## ROTAX. SERVICE INFORMATION

1 UL 94-E

### Electronic box for ROTAX 912 A and 912 UL

Nr. 897 695

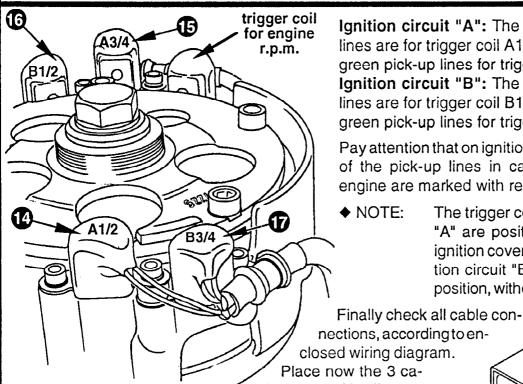
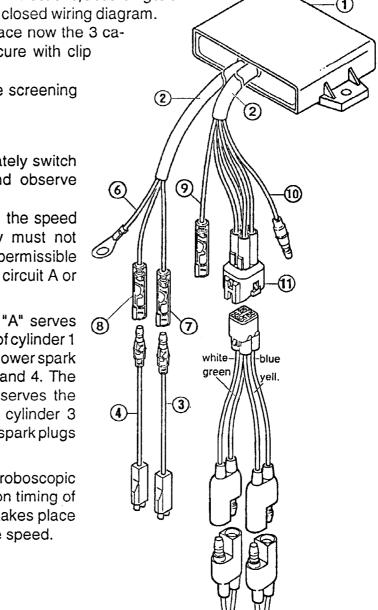
Since introduction of the SMD Ignition unit, the electronic box, part no. 965 320, used up to now, can't be supplied any longer. This electronic box was installed in the AL-screening box on all engines Type 912 since the start of serial production.

As the new electronic module used is furnished with different plug connections, appropriate new adaptor cables are necessary for the primary and pick-up lines from engine to electronic module.

Replace faulty electronic box by installing the a bit smaller electronic module 1 in the screening box. The larger free space remaining now can be stuffed with additional filling material. To ease the routing of the adaptor cables, it is advisable to shorten the end of the insulating hose 2 of the 3-strand and 6-strand cable assemblies to c. 1 cm (3/8").

The electronic module comes with 2 cable assemblies, one with 3 cables and one with 6 cables. These cables have to be connected by means of the cable adaptors 3, 4 and 5 to the existing wiring.

The black cable with the M6 cable shoe has to be grounded together with attachment of ignition coils. Connect the white cable with plug socket via primary line adaptor 966 355 with the respective ignition coil A3/4 or B3/4. The yellow cable has to be connected via a primary line adaptor 966 355 with the respective ignition coil A1/2 or B1/2. The brown cable from the 6-strand cable assembly has to be connected with the white cable of the capacitor.

Connect the pink cable with plug to the red charging line of the respective ignition circuit. Connect the 4-pole plug to with the pick-up line adaptor 5 966 350, followed by connecting the 2-pole plug of adaptor with the existing 2-pole plug of the pick-up line.

Ignition circuit "A": The yellow-blue pick-up lines are for trigger coil A1/2 @ and the whitegreen pick-up lines for trigger coil A3/4 (5). Ignition circuit "B": The yellow-blue pick-up lines are for trigger coil B1/2 6 and the whitegreen pick-up lines for trigger coil B3/4 7.

Pay attention that on ignition circuit "B" the ends of the pick-up lines in cable assembly from engine are marked with red sleeves 18.
